HPSII Phosphate Mine

Alachua County Concerns

Anthony Janicki
Thomas Crisman
Patrick Tara
Sam Upchurch

SW Pre- and Post-mining Mine Wide Basin Modeling

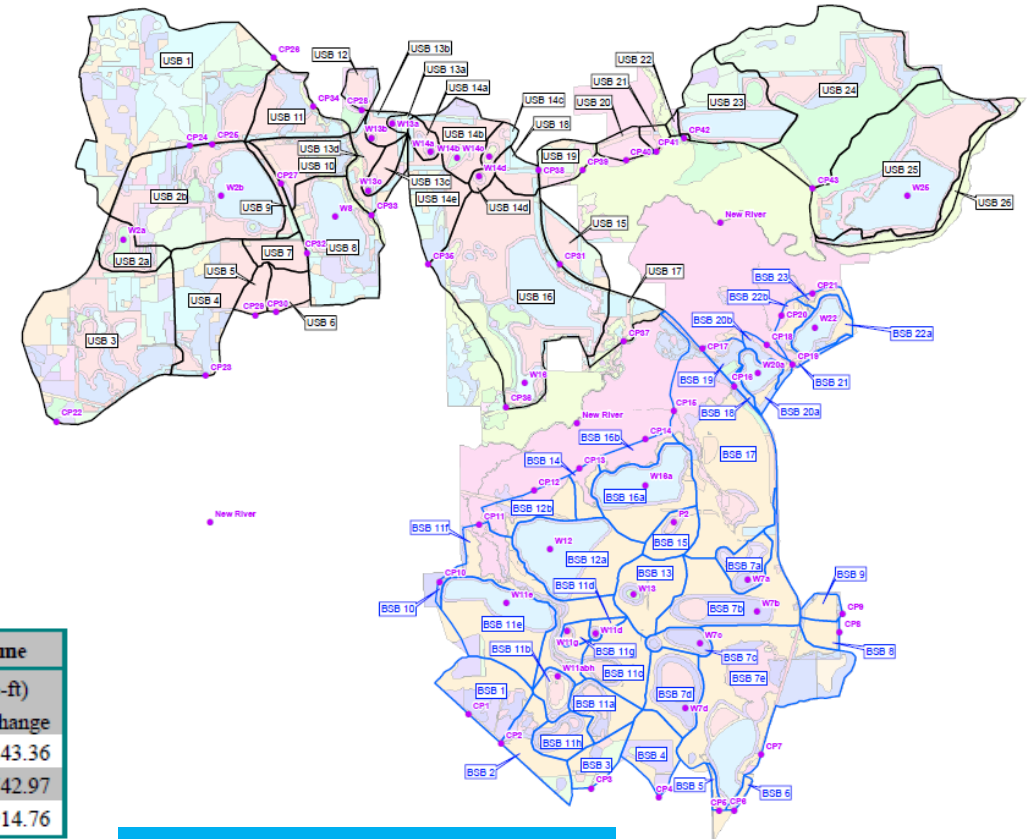
- SW modeling was event based
- Continuous model is required to evaluate impacts to the MFL

Figure 1. Annotated Topographic Map with Stream Gage Stations

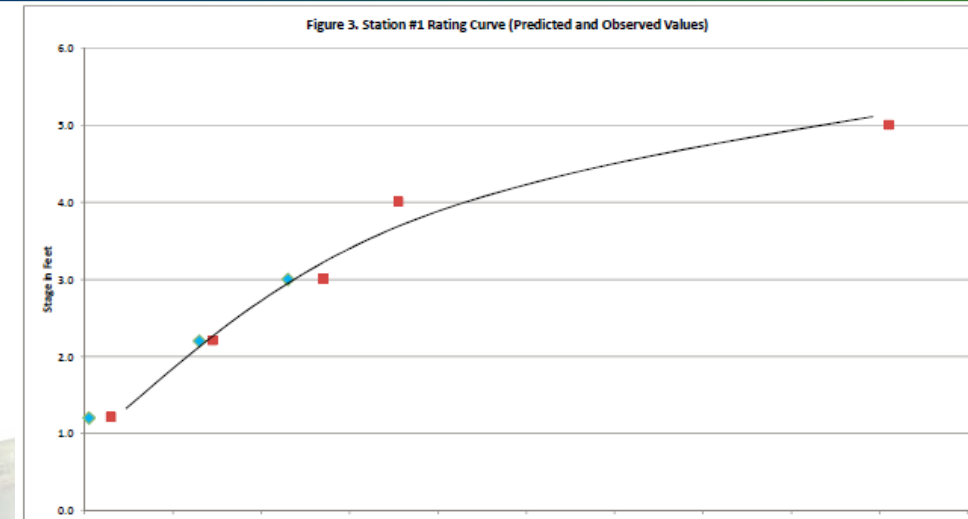
- Stage/Discharge relationship should not be changing since river and riparian area are not directly impacted
- Point calibration does not account for shoaling present throughout the system, Figure 8
- Spreadsheet models are poorly constrained at high flows
- Does not address the impacts to flow from changes in land use/land cover

Figure 1 Water Balance Modeling Overview

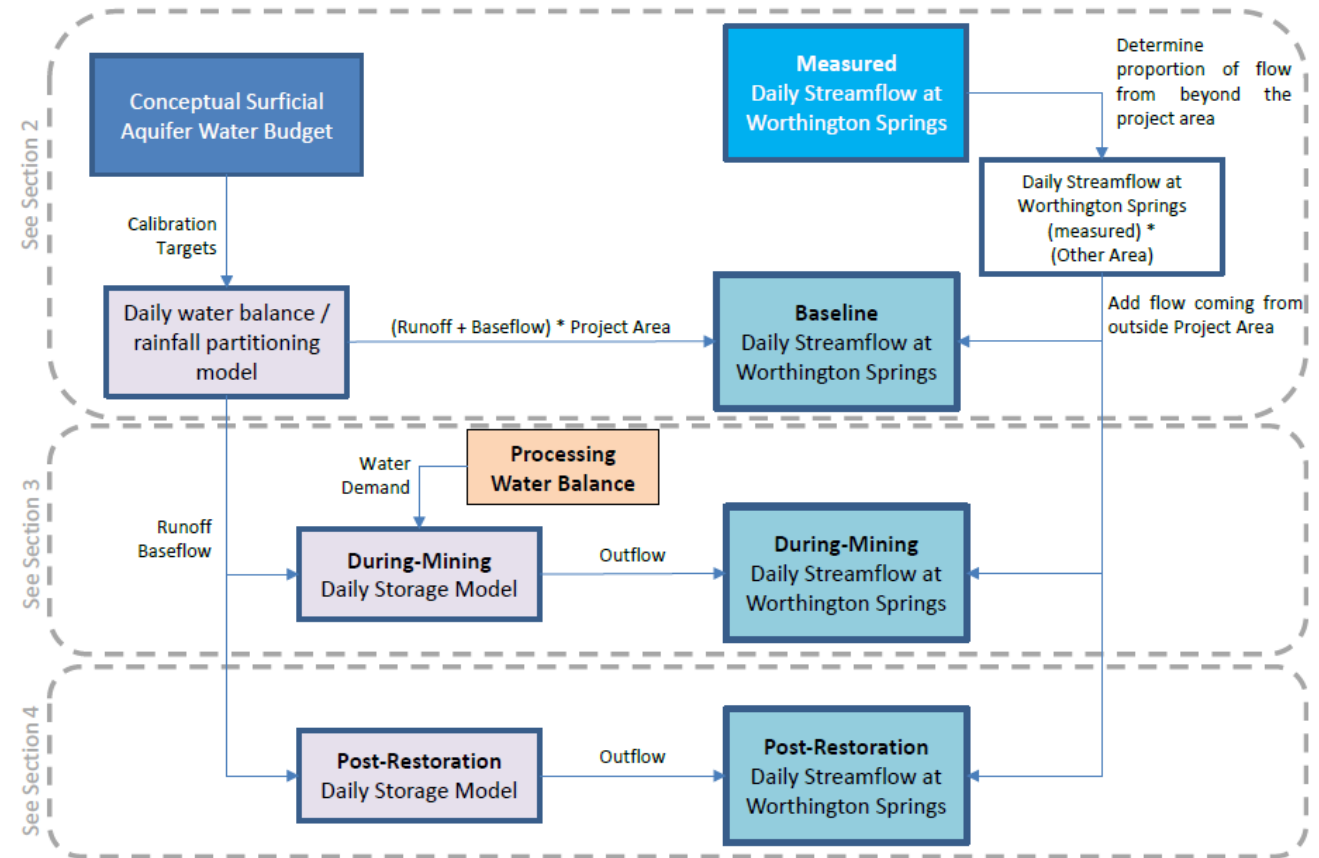
- Complex water balance deals mostly with process water within mine operations
- Stormwater capture/recovery accounts for over 50% of the proposed mine water needs, this supply will reduce low flows in the New River
- Does not address land use/land cover changes and associated impacts to the basins hydrologic response

FIGURE
C-3

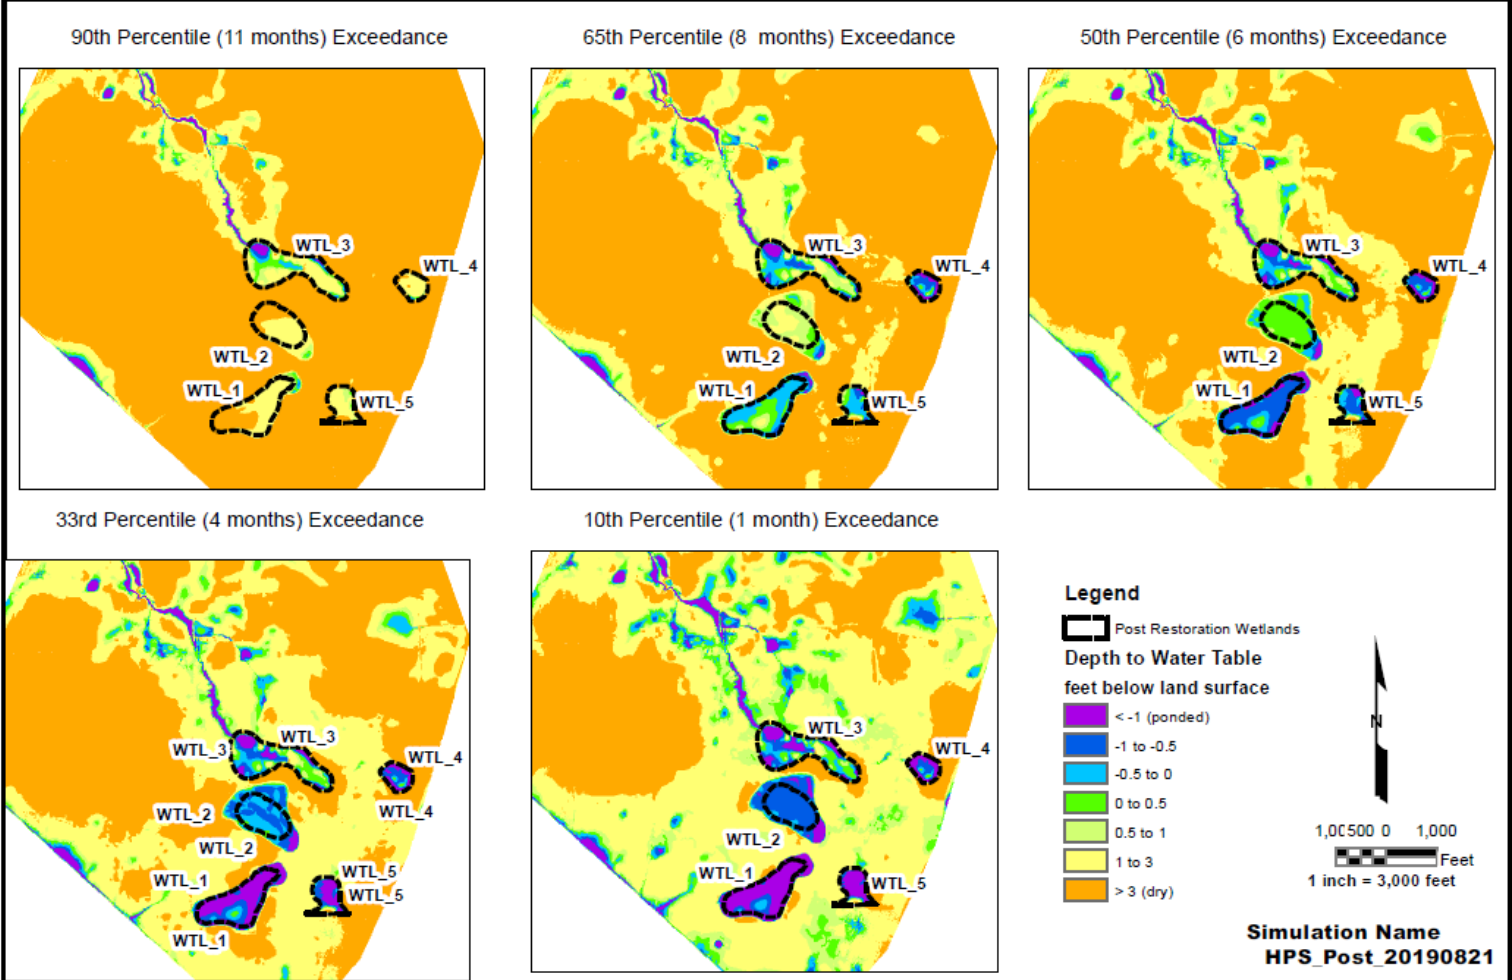
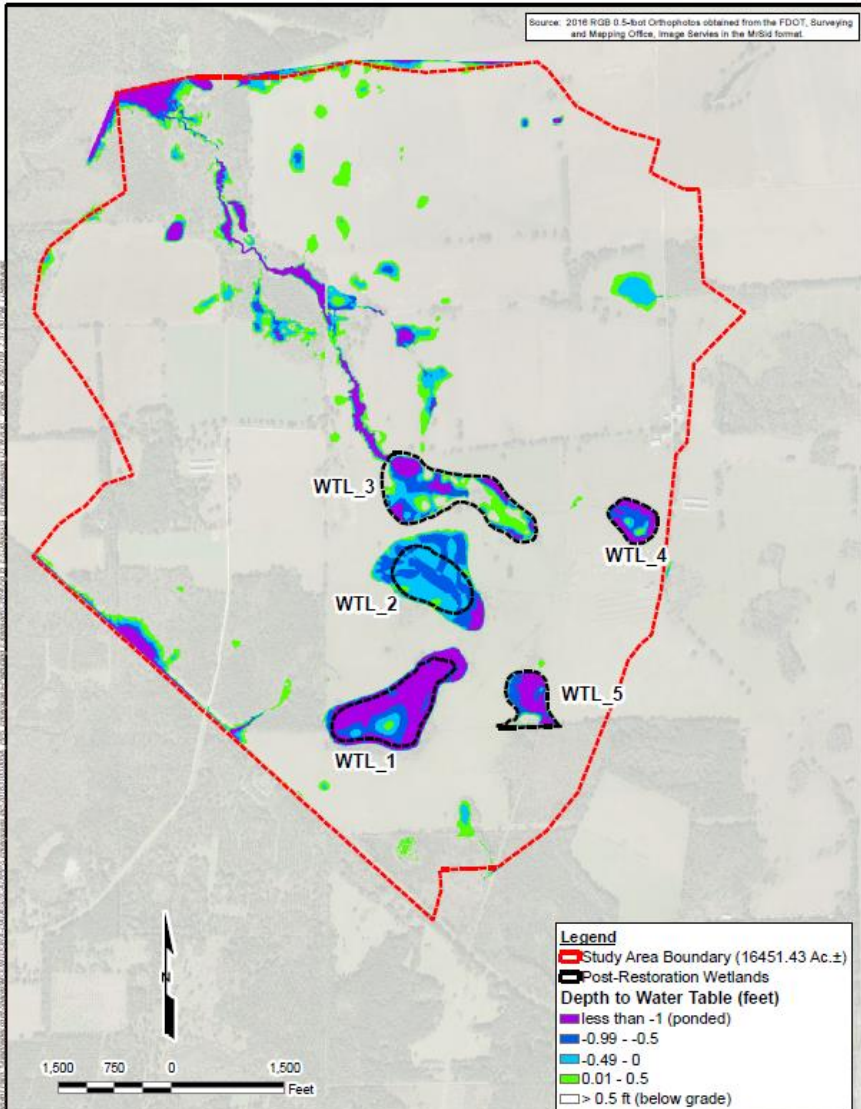
- ICPR4 model is not mine wide
- No surface water calibration, therefore uncertainties exist in the predictive capability of surface water model and water balance
- Post-reclamation parameterization is not founded with observed sand clay properties
- Water balance addresses process water but not land use changes and consequent changes to hydrologic response

Post-Reclamation Land Cover

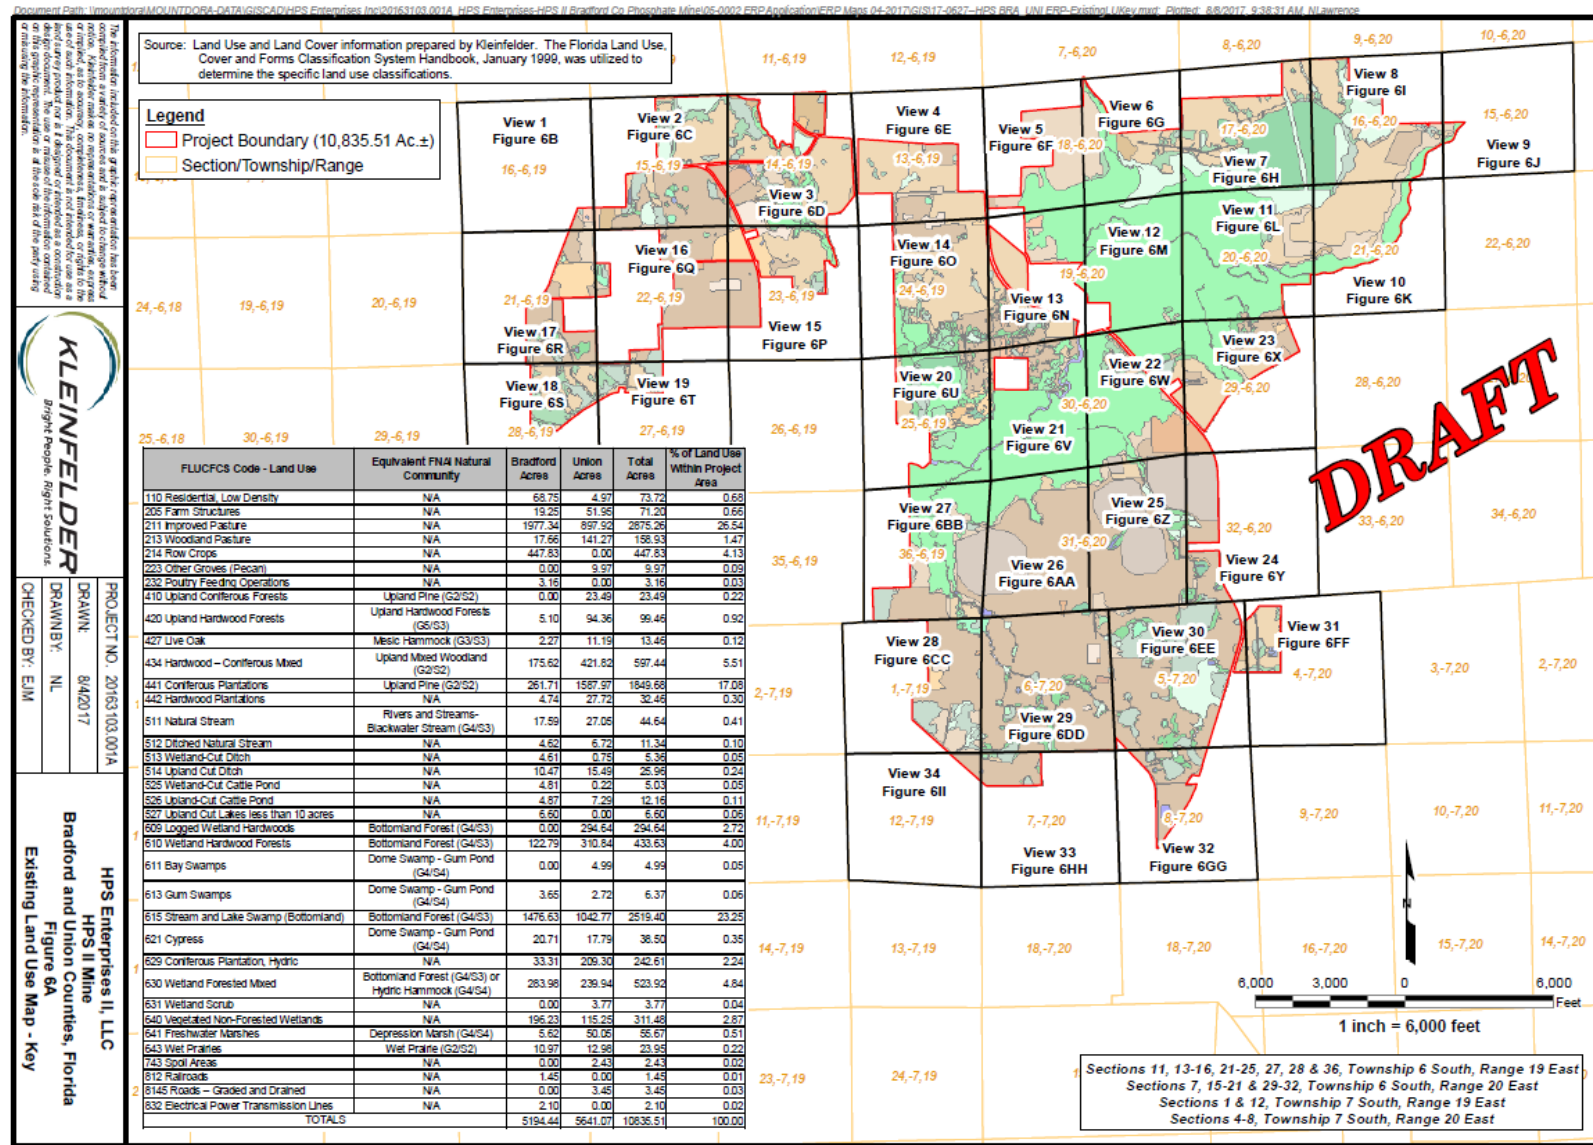
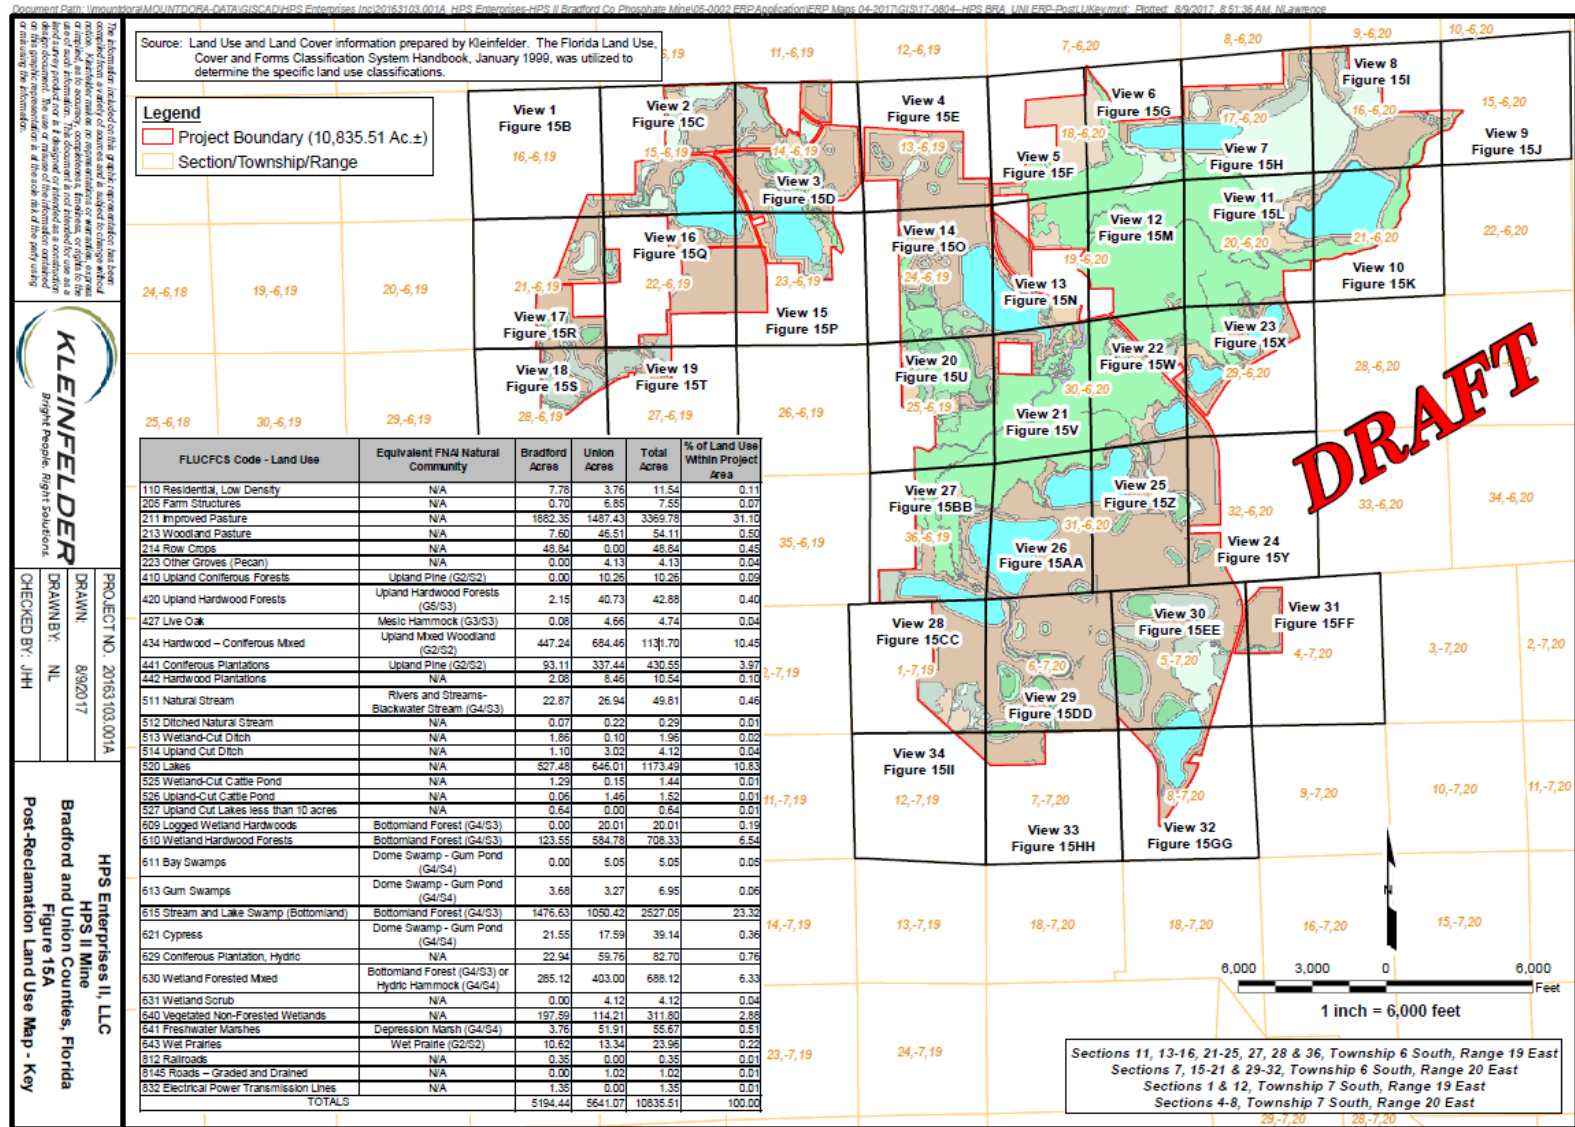
- About 2 square miles of lakes will be created as part of the reclamation plan
- Lakes evaporate at or near Potential ET rates, **dramatically** reducing the water that could leave the site
- Event based modeling ignores ET losses, continuous modeling captures impacts from changing land use

- Note the large lake areas in the reclamation plan

Conveyor Crossing Plan

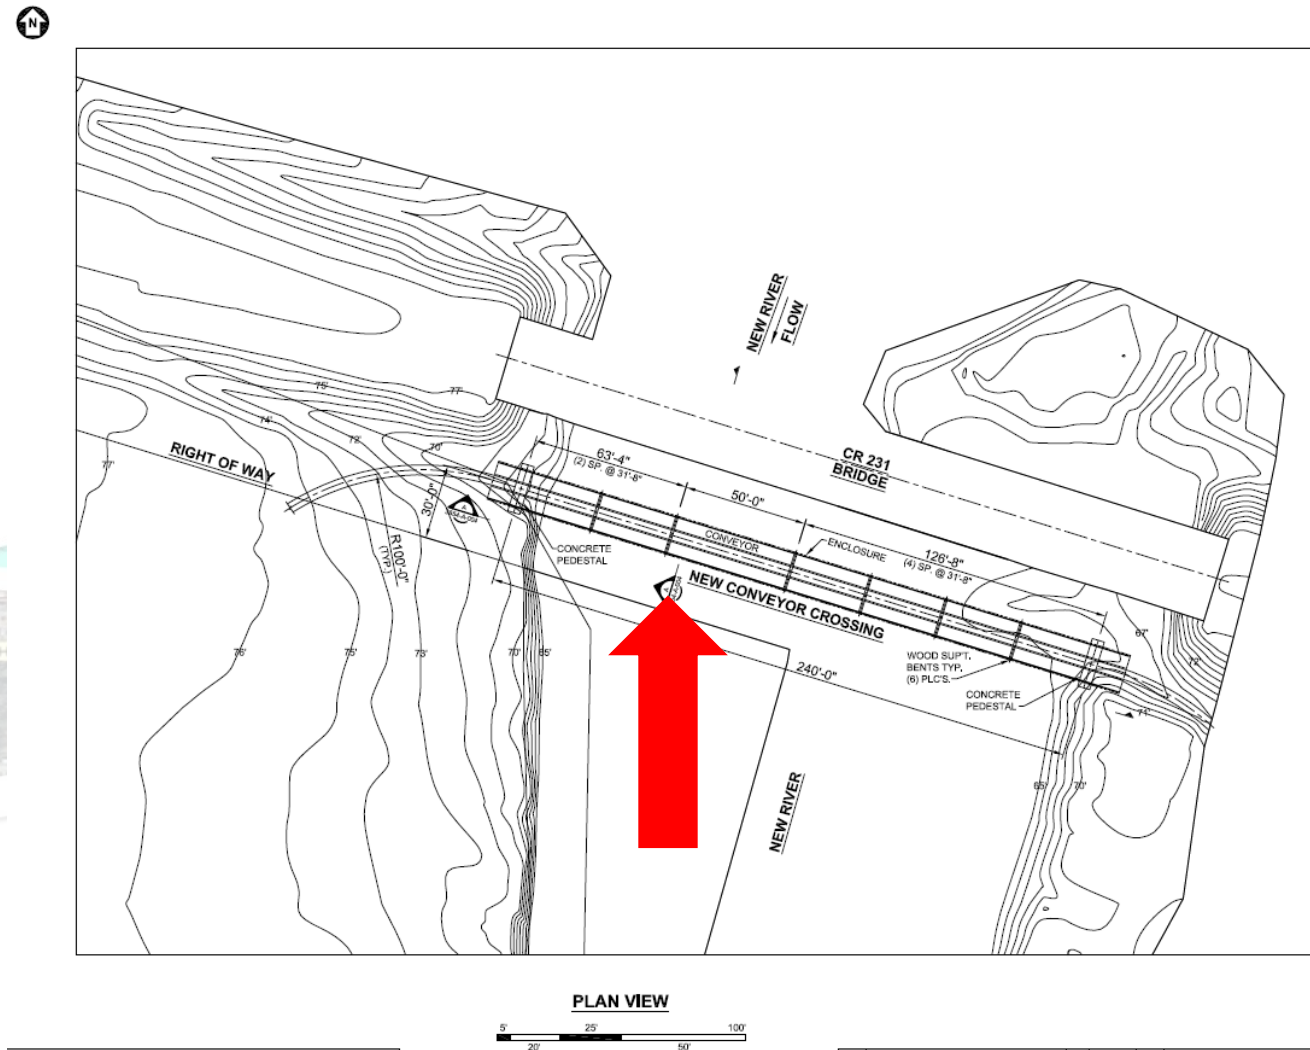
- Hydraulic impacts at river crossing
- The many piers in the channel will cause additional erosion
- The conveyor crossing is extended towards an area where the principle axis of the river more north-south
- Additional debris accumulation possible
